RFQ NUMBER
RMA900010

Addendum #2

This addendum will completely replace the original RFQ for RMA900010. All changes from the original will be in italics. Removed sections will be shown as strikethroughs. PLEASE READ CAREFULLY AS SOME MATERIAL REQUIREMENTS HAVE CHANGED.

The West Virginia Purchasing Division for the agency, The West Virginia State Rail Authority is soliciting bids for track construction, crosstie and bridge tie replacement and surfacing. All work is located on the West Virginia Central Railroad (WVCR).

Attachment A

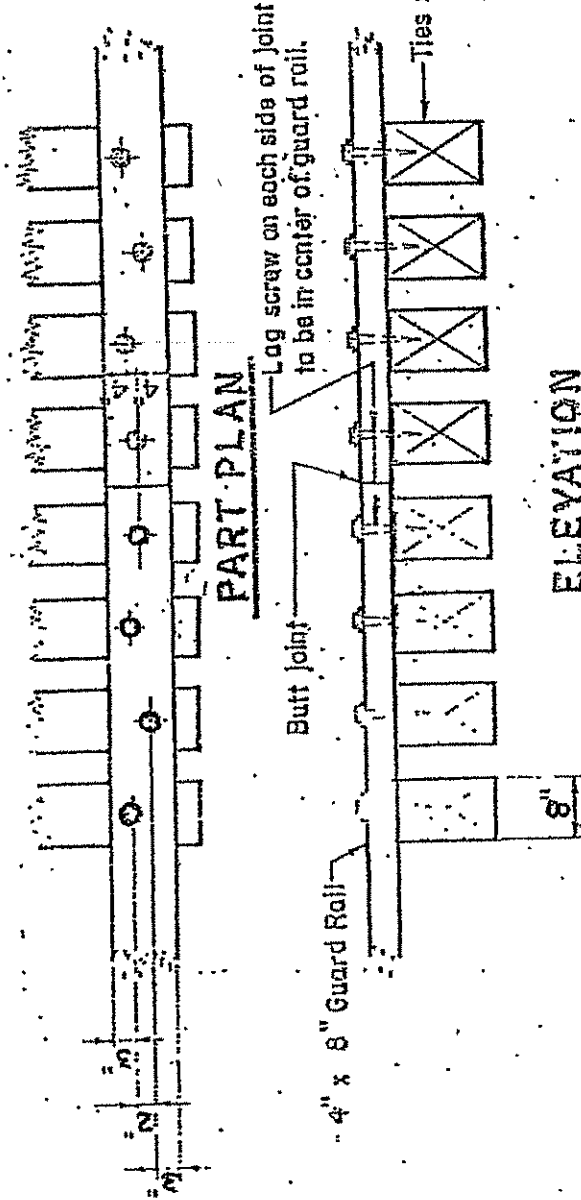
2. Steel Strap Tie Spacers are to be replaced on new bridge ties exactly as they are currently placed on existing ties.
3. Inner Guard Rail: The inner guard rail on the bridge shall be re-installed as shown in the attached sketch. *(Attachment A)* The rail will be spiked to each tie with two spikes per rail, without plates, and will be fully bolted. There are 9 joints per rail, four bolts will be used for each joint. Contractor can reuse joint bars and supply new bolts and washers. NOTE: Some discussion took place at the pre-bid concerning a change in the number of ties needing to be spiked. There is no change to what is listed here.

Handrailing

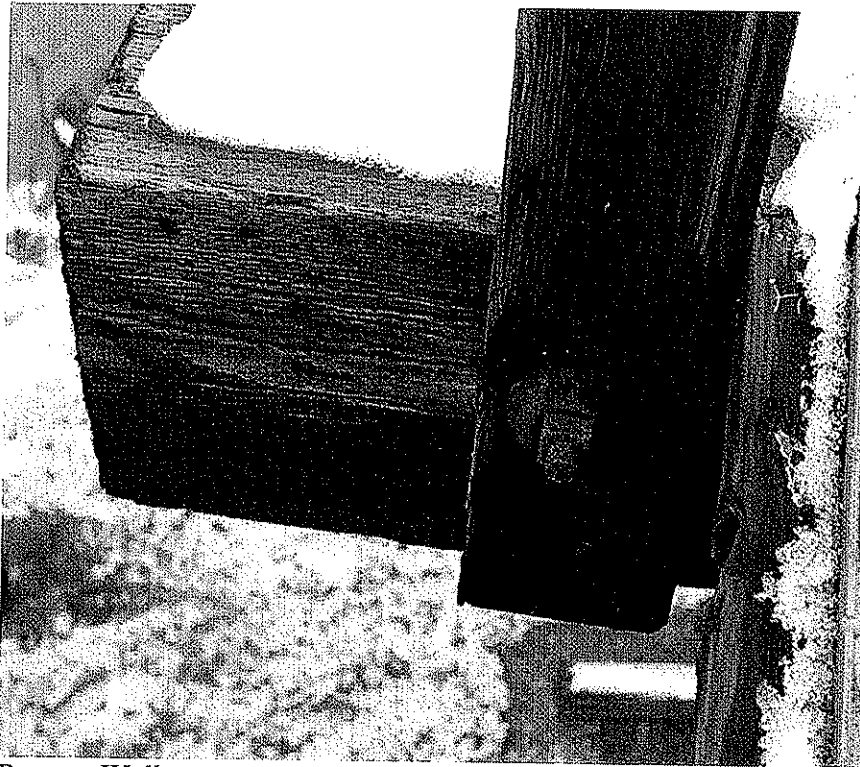
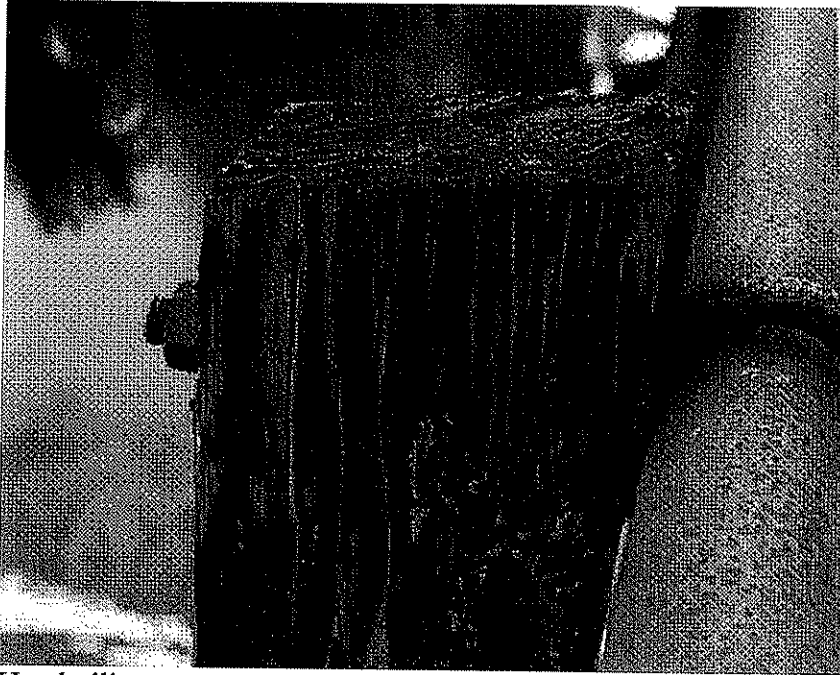
5. Walkway: The timber on the walkway will be replaced and the metal walkway re-installed. (68) 3" x 9" x 14' timbers will be cut to fit for the walkway. The posts for the handrail will be replaced and the existing handrailing will be reinstalled. (33) 3 $\frac{1}{2}$ " x 5 $\frac{1}{2}$ " x 58" treated lumber posts will be replaced. *The metal grate is attached to the walkway with a nail and metal clasp. The walkway boards are attached to the walkway support timbers with nails. Contractor is to replace in kind. See pictures showing detail of post and handrail attachment.*
